Access Compliance Report

Public Rights-of-Way (Curb Ramps)

Intersection ID: 13189	Main Street: HAWTHORNE_LN	Cross Street: SUNNYSIDE_AV	Location: NE
ADA ID: E805562C7000	Ramp Type: Directional1	Initial Pass/Fail: Pass	Overall Compliance: No
		Severity Score: 7.5

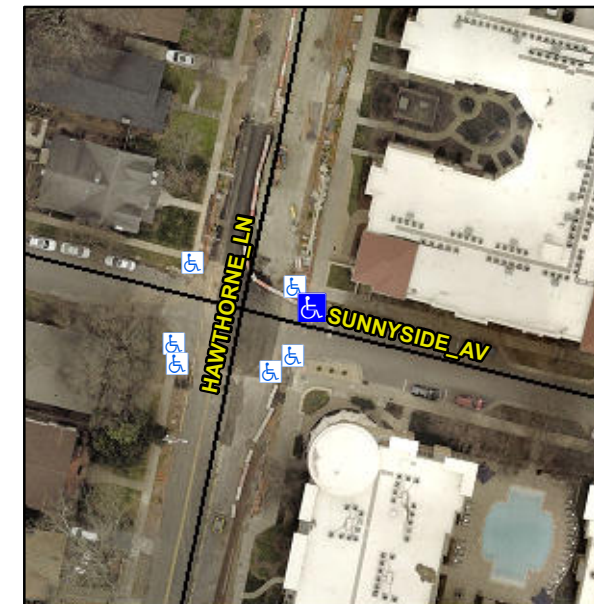
Remove & Replace Detectable Warning System. Remove & Replace Gutter. Utility Present.

R305.1.4, R304.5.4, R302.3, R402.2
